**Nisqually Landing Apartments Public Hearing
Staff Report & List of Exhibits
September 16, 2021
Case #: 2021.0023**

Case Number: 2021.0023

Request: Construct a 60-unit apartment complex with planned residential development zoning overlay

PRELIMINARY SITE PLAN

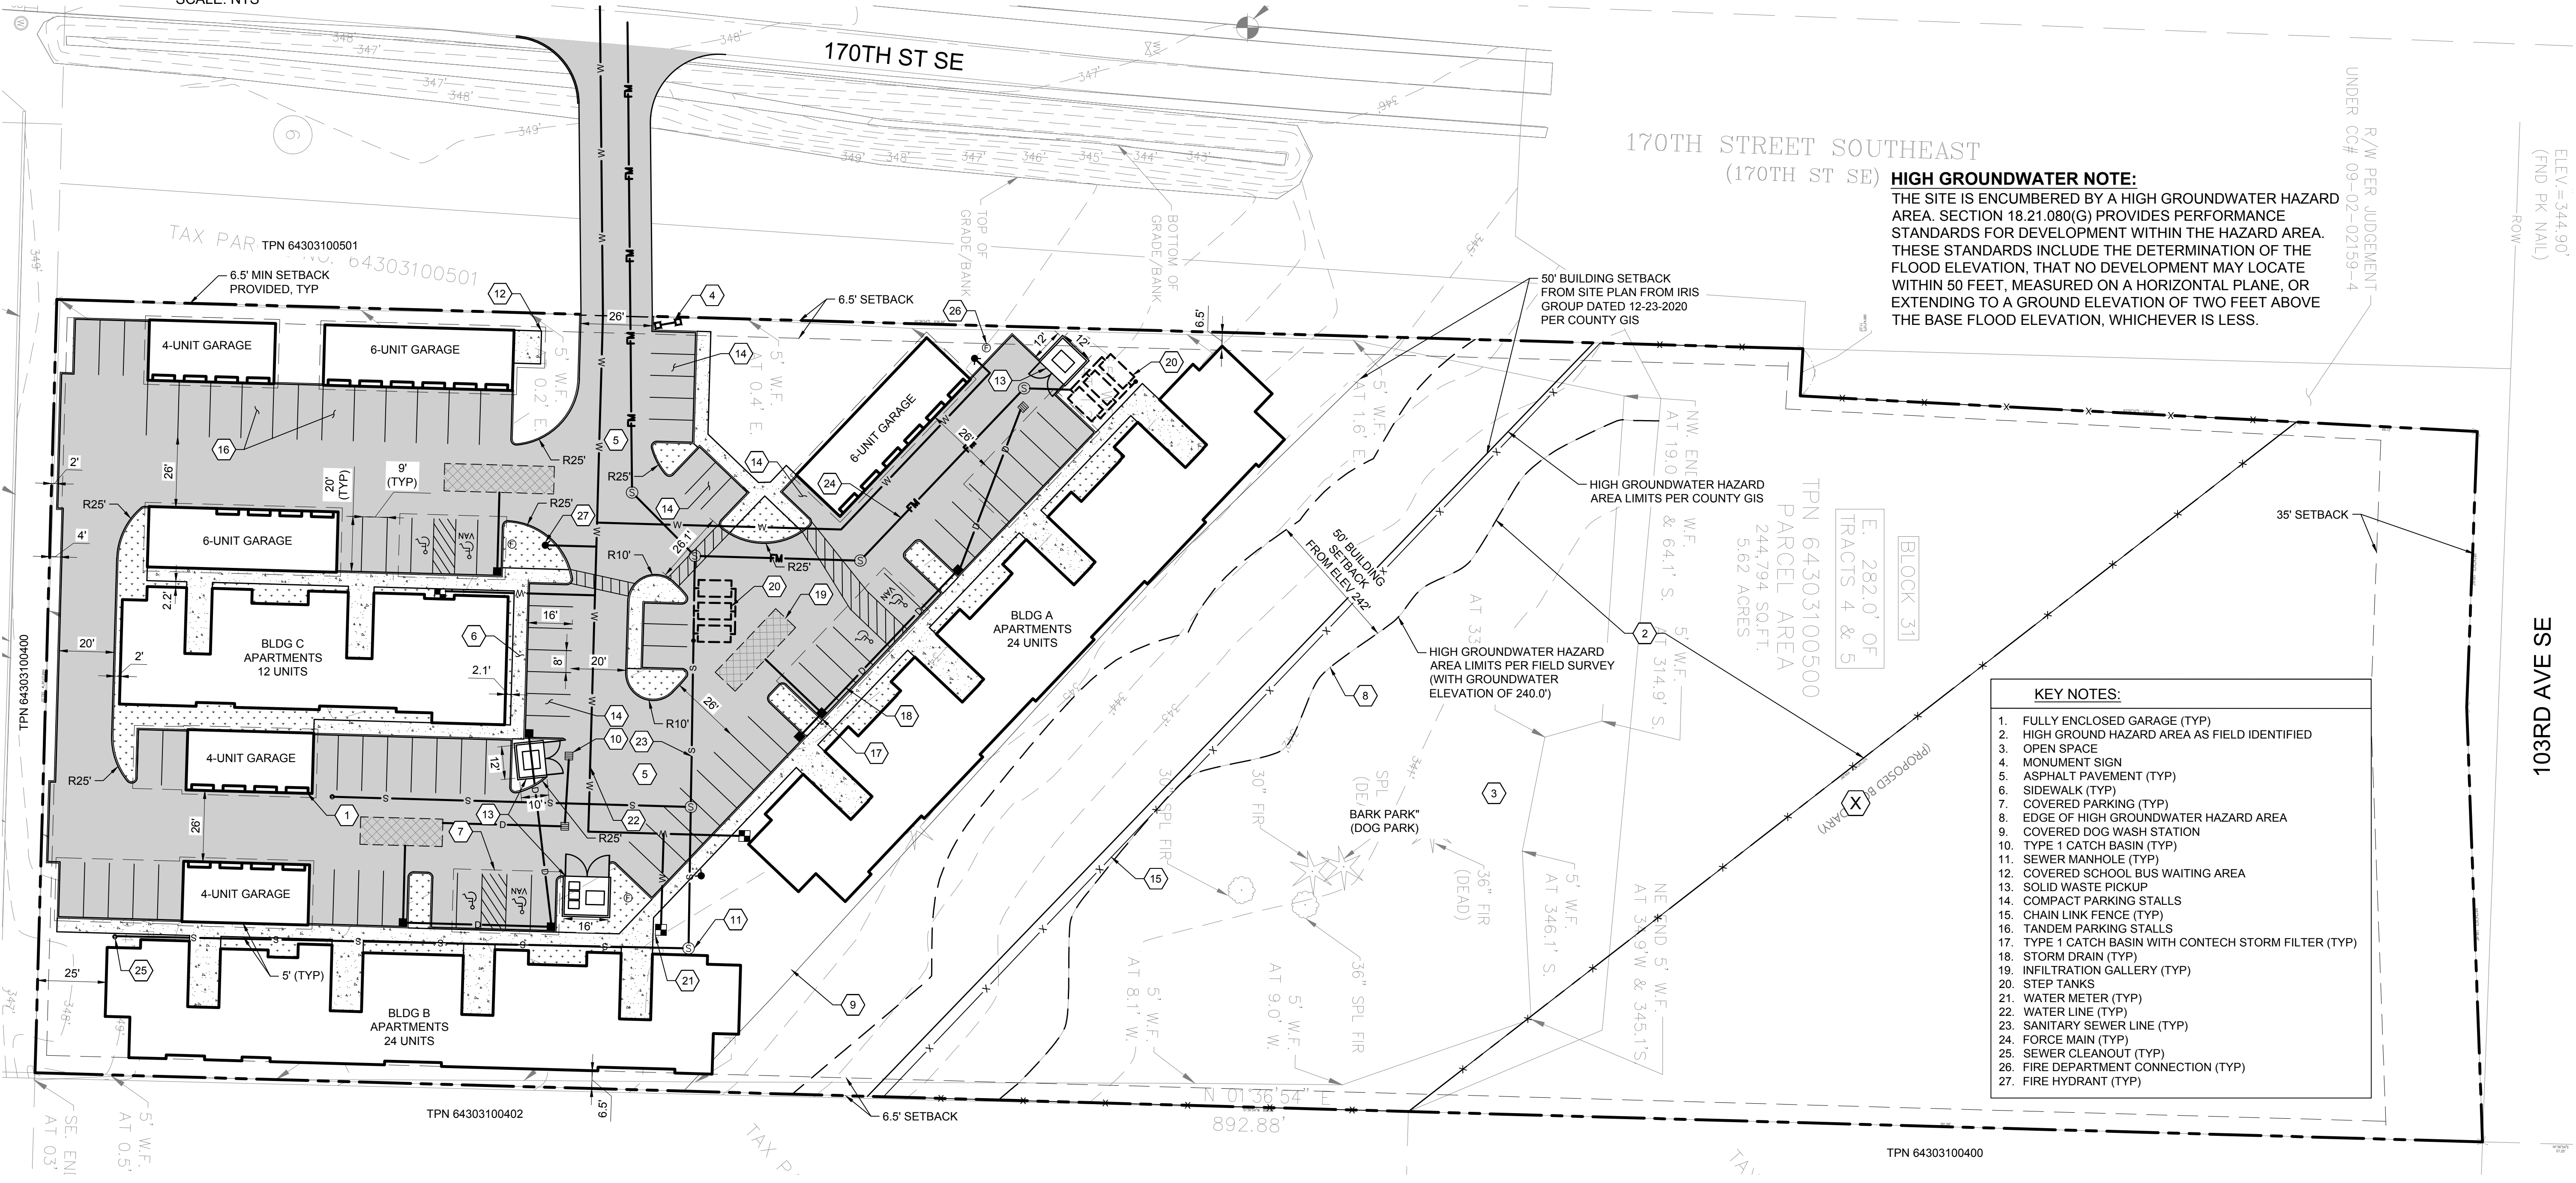
Parking landscaping includes a minimum of 24 square feet of landscape area for each parking stall proposed, planting area must contain at least one tree with no parking stall located more than 50 feet from a tree. The proposed site plan does meet parking lot landscaping requirements. Parking lot landscaping meeting the standards of Section 18.55.020(D) YMC is required at civil plan submission.

public sidewalk and substantial landscaping when parking is located adjacent to street frontage. It is unclear if the preliminary site plan provides pedestrian access from 170th St SE (Yelm Loop), and between the dwelling unit buildings. Pedestrian pathways should be provided from parking areas to the buildings, and from the public sidewalk to the development.

Section 18.61.050(B) YMC prohibits chain link fencing when visible from the street. Chain link fencing is shown along the edges of the high groundwater hazard area. The applicant shall provide detail of other fencing or landscape screening at civil plan submission.

6. Fencing along the east property line ending at the high groundwater hazard area will be shown at civil plan submission.
7. Parking lot landscaping meeting the standards of Section 18.55.020(D) YMC is required at civil plan submission.

10. The applicant shall provide fencing detail in compliance with Section 18.61.050(B) YMC at civil plan submission.

11. Civil plans shall show compliance with Section 18.21.080(G) YMC regarding development in the HGWHA. A pedestrian pathway to the dog park is required and shall be shown on the final landscape plan.
